Waste and Resource Recovery Services (WaRRS)

Development Assessment Team – City Plan 2014 Assessment

Assessing Officer	Paul Stone	Assessment Date	17/06/2026
Application Date	3/06/2026	Properly Made Date	15/06/2026
Application Ref	A007041733		
Site Address	73 BRISBANE ST TOOWONG QLD 4066 6 JOSLING ST TOOWONG QLD 4066		
Permit Type	DA - PA - Material Change of Use		
Activity	Request to change approval under PA s81 (Minor Change) - Multiple Dwelling and Short-Term Accommodation (40 units)

Figure 2: Approved ground floor plan

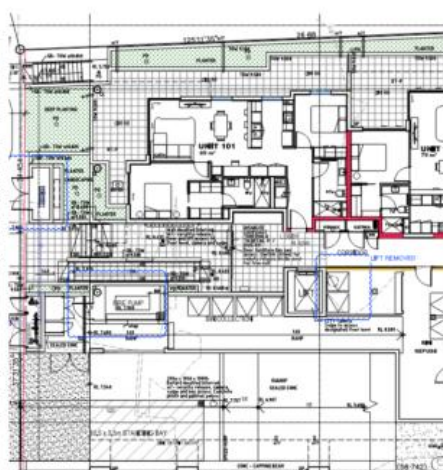
Additionally, the front landscape planter has been extended in direct response to Council's amendments in red on the approved drawings. As a whole, it is considered the ground floor changes are minor in nature and do not result in any major alterations to the approved design as illustrated in Figure 2 and Figure 3.

Figure 3: Extract from amended section - 3.98m refuse vehicle clearance

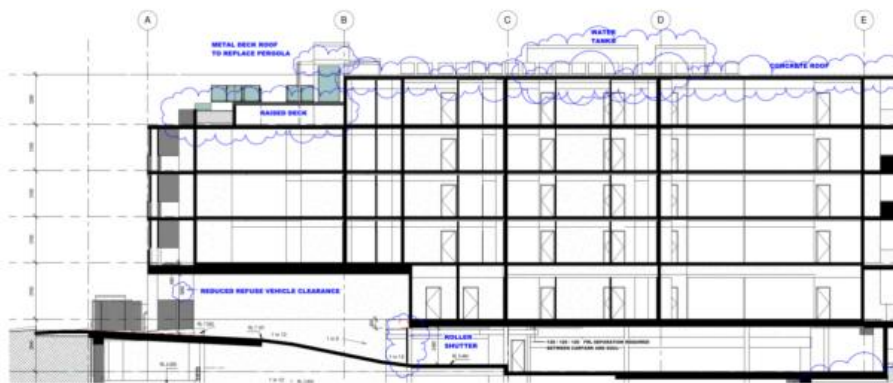
The amended section identifies a reduced refuse vehicle clearance of 3.98m at the driveway/refuse collection interface. This is only a minor reduction from the approved section and remains greater than the 3.6m practical clearance referenced for the rear-loader collection arrangement. The amendment does not change the vehicle path, the driveway standing area or the basement parking circulation requirements.

To the extent Condition 15(iii) is read as requiring the original 4.054m clearance at the refuse vehicle standing position, Council may wish to update that condition to reflect a minimum of 3.6m clearance. In functional terms, the available clearance remains acceptable for the approved rear-loader collection operation.

Ground Floor (Level 1) Plan, Dwg No. DA100, Issue A

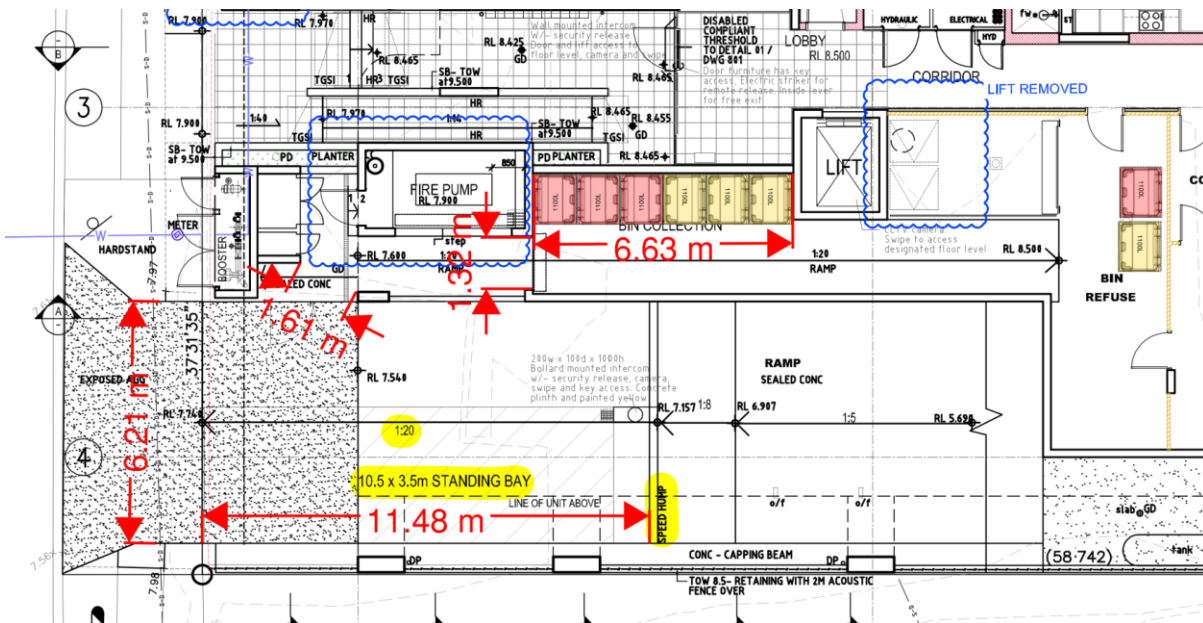
- 1. Despite the Bin Collection room being decreased in size, it remains functional. However, the dimensions for the Bin Collection and Bin Refuse rooms have been deleted from the proposed plans.
 - a. In accordance with PO32/AO32 of the Multiple dwelling code, demonstrate on amended plans the dimensions of the Bin Collection and Bin Refuse rooms.**
- 2. The intercom blocks the transfer of bins to the rear of the Refuse Collection Vehicle (RCV). Bulk bins cannot be transferred over gradients greater than 1:20. Demonstrate on amended plans a clear transfer path for bulk bins to the rear of the RCV (ensure there is a minimum 1.5m between the gradient change and the intercom). Provide updated RPEQ certified swept path analysis if the relocated intercom affects the manoeuvre of the RCV.*

- Proposed s81 to a multiple dwelling/STA.
- Changes include removal of a lift which makes the chute room bigger, changes to the fire pump which makes the bin collection area smaller and a reduction in the vertical clearance from 4.054m to 3.98m. Despite the reduction in the bin collection area, it remains functional due to the adjacent bin refuse room.
- The dimensions of the bin collection and bin refuse rooms that were on the approved plans have been deleted from the proposed plans. These need to be reinstated.
- The 6.2m wide type B2 crossover and internal aisle were previously approved.

Sections, Dwg No. DA410, Issue A

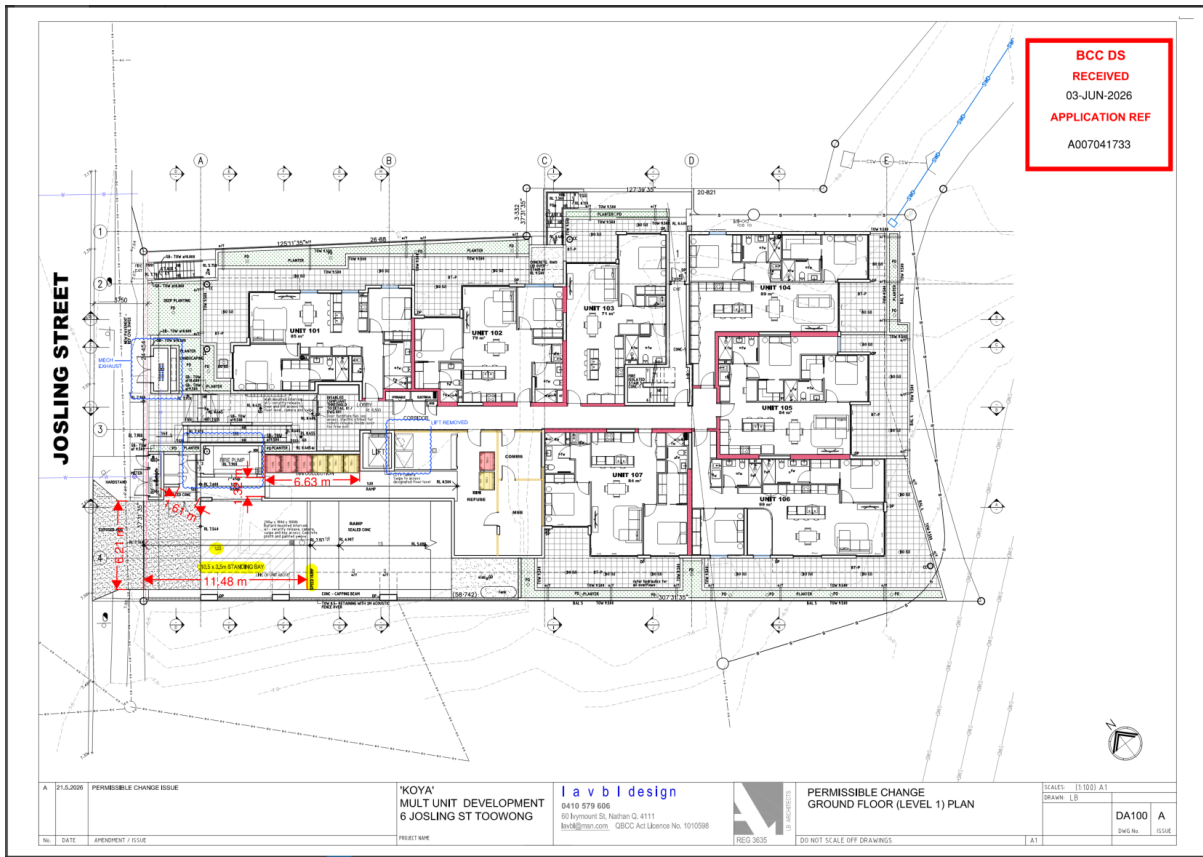
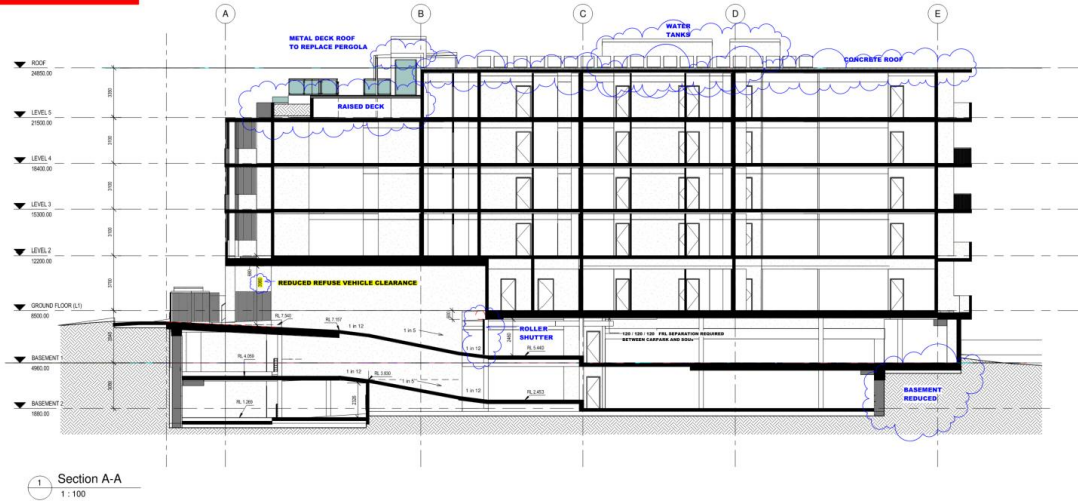
The development proposes to make changes that include a reduced vertical clearance of 4.054m to 3.98m, a reduction in size to the Bin Collection area and increased chute room area. Despite the reduction to the Bin Collection area, the approved refuse solution is still functional. However, it is noted the dimensions for the Bin Collection and Bin Refuse rooms have been deleted. Therefore, the following item will need to be addressed.
